MEMORANDUM

To: Development Review Board
From: Mary O'Neil, AICP, Senior Planner *MO*
Date: April 1, 2014
RE: ZP 14-0784SP

Location: 247-249 Pearl

Request: Sketch Plan review of proposed redevelopment to include three story residential building with 29 residential units and surface parking to the east and south.

DATE: FEB., 2014
 SCALE: 1" = 20'
 PROJ. NO.: 14103.01
 DRAWING NUMBER: **C1.1**

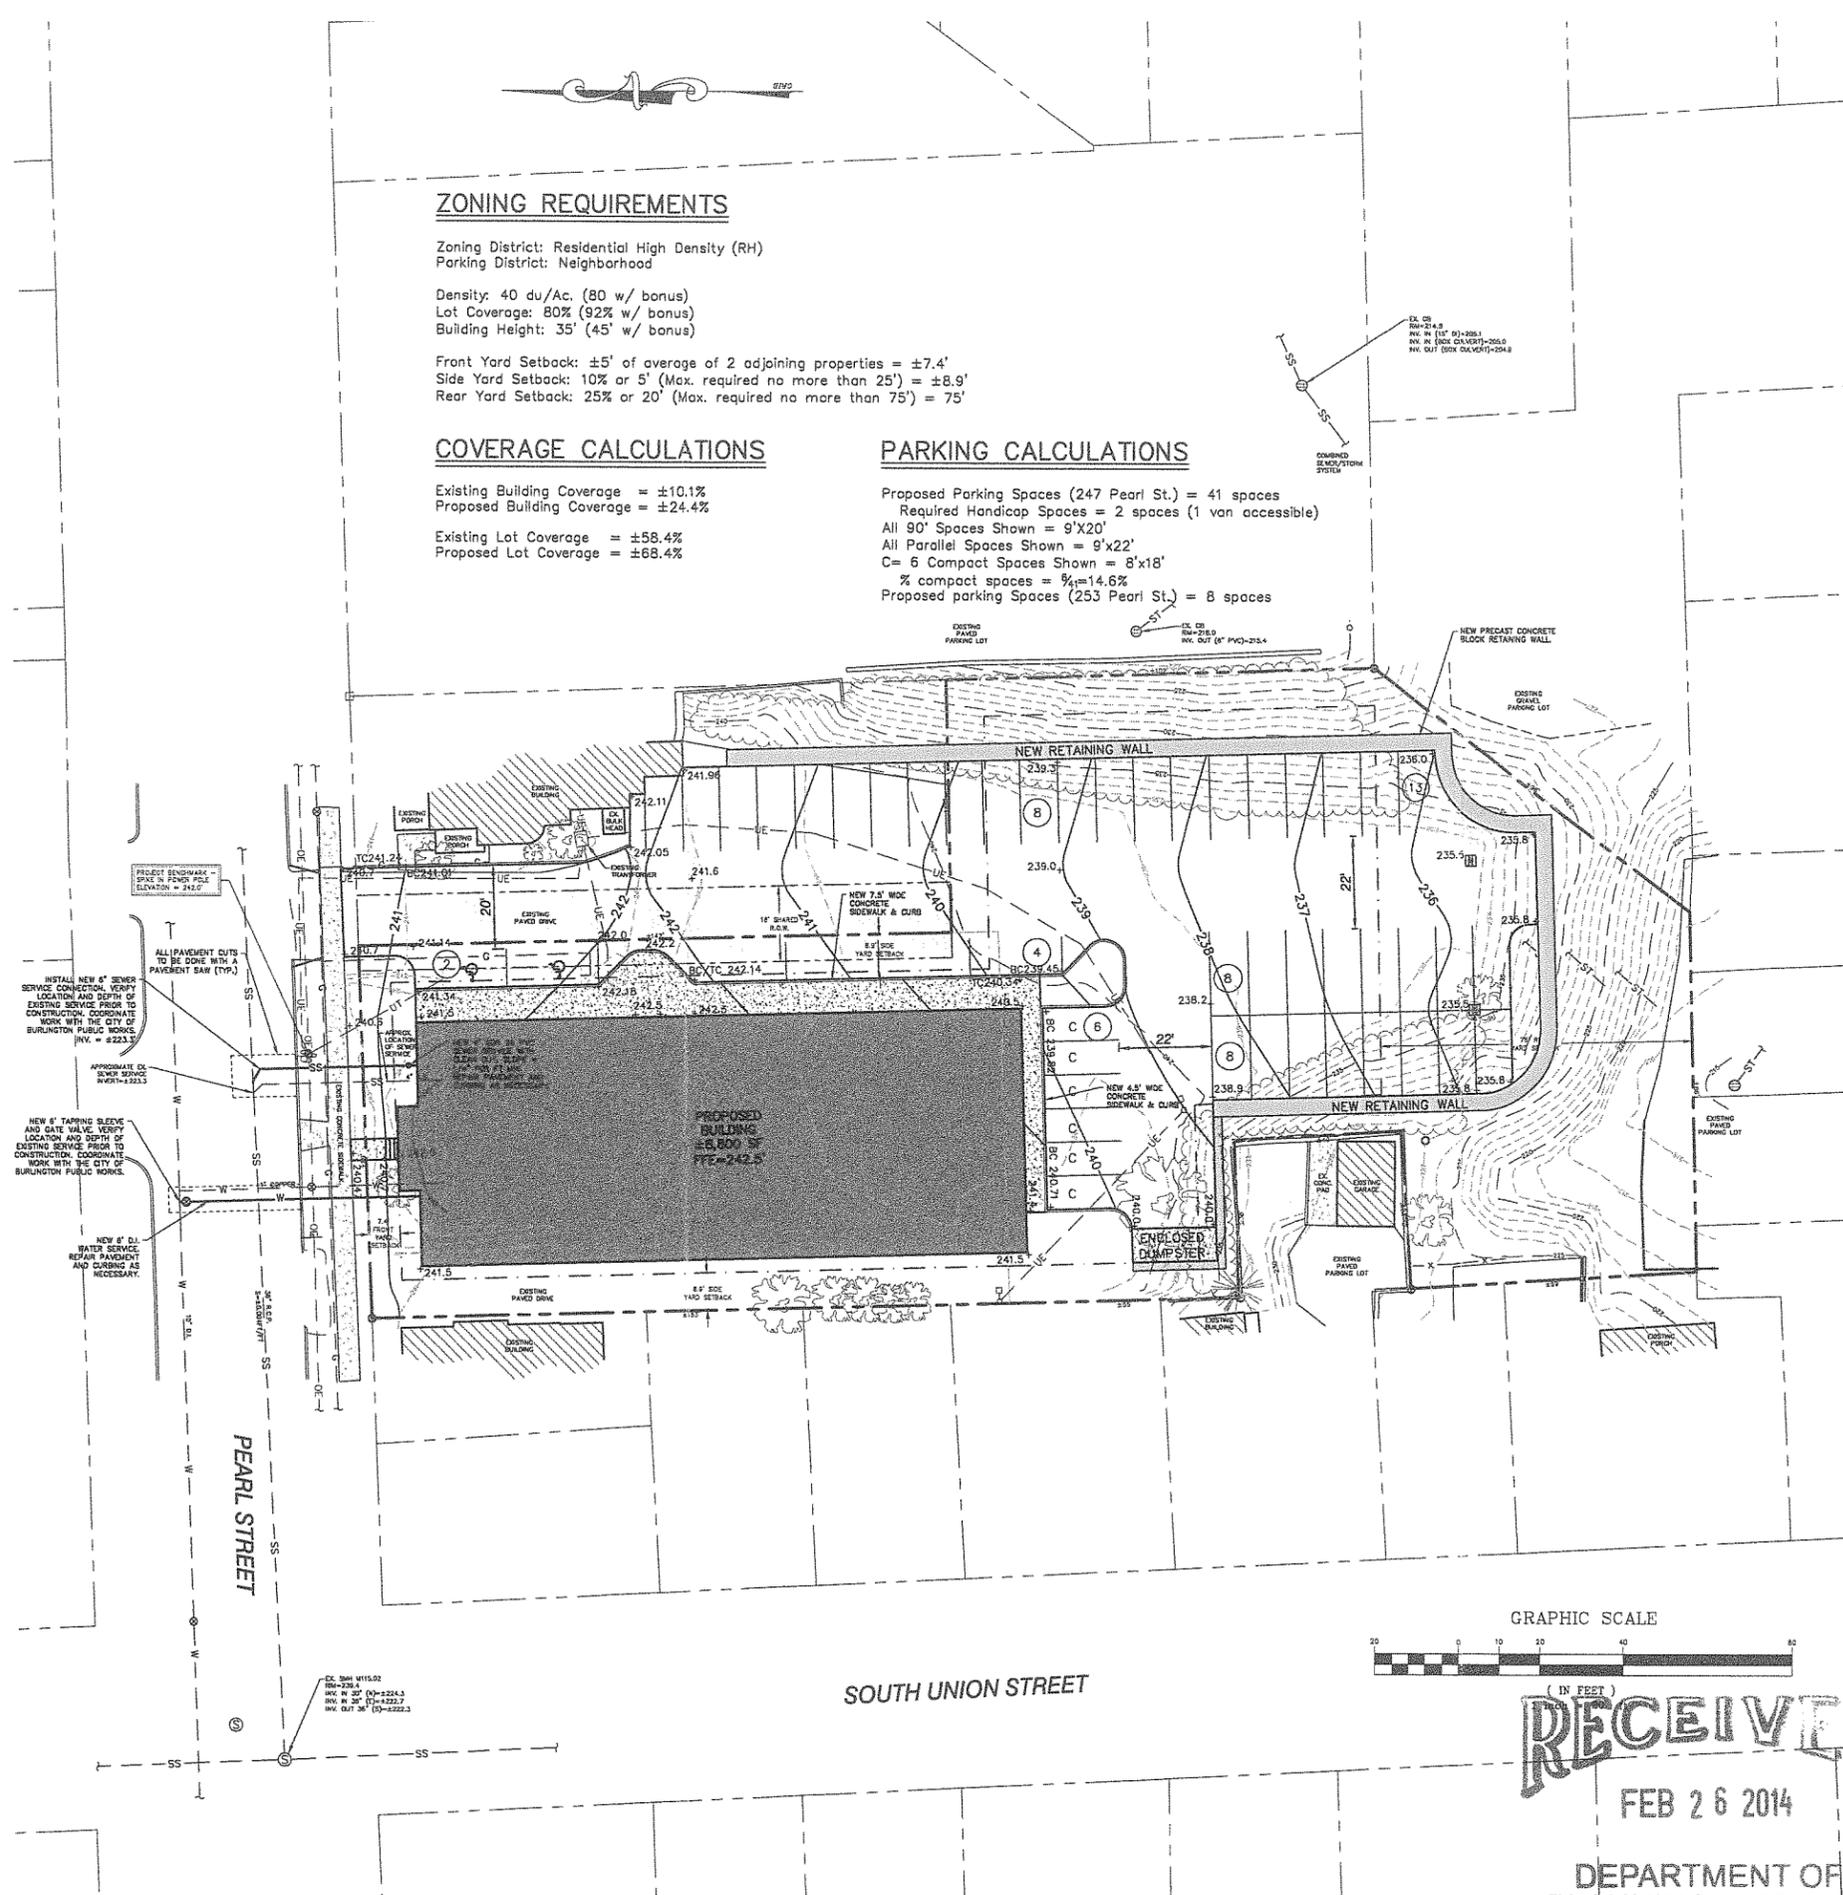
The site plan has a significant flaw, in that **the proposed building encroaches into the (westerly) side yard setback where the property widens** – the setback should reflect this change of lot width, with a corresponding alteration and recess of the building plane.

Some grading changes are proposed for the parking lot area; beginning the grade slope sooner than exists today and abutting the plan with a significant retaining wall, height or width undetermined. The wall will be required to meet the approval of the city engineer per this standard. As described, the preformed concrete block will have little affinity for the surrounding residential use.

This portion of the plan is flawed in that the side yard setback is not met on the site plan at this location, and the building itself will have to be revised to meet setbacks. This will undoubtedly spur redesign of the parking.

Only a dumpster, abutting the retaining wall is identified on the site plan. This dumpster is proposed to be approximately 10' above the immediately abutting single family property to the west. The abutting neighbor spoke at the DAB hearing, expressing displeasure at the proposed height of the feature, above his back yard. Some meaningful method to soften that transition, which may include landscaping is in order.

15% of parking may be identified as compact (8' x 18') parking. $.15 \times 41 = 6$ parking spaces. These are illustrated directly south of the proposed building. This configuration is likely to change with revisions to the site plan to comply with sideward setbacks. Additionally, these may prove problematic, as any cars greater than 18' long will likely block trash haulers from getting to the dumpster. The applicant will need to assure that appropriate (20') minimum back-up space is afforded for these spaces.

The site plan illustrates 2 h/c parking spaces adjacent to the pedestrian walkway on the east side of the building. Dimensions are not clear; however the applicant must confirm that these provide the required 5' access aisle without extending into the driveway access aisle, putting people in harm's way. If the sidewalk is designated and acceptable for meeting the access requirement, the applicant shall define.

The site plan and building footprint will be required to be revised to reflect conformity with required setback, once it is determined.
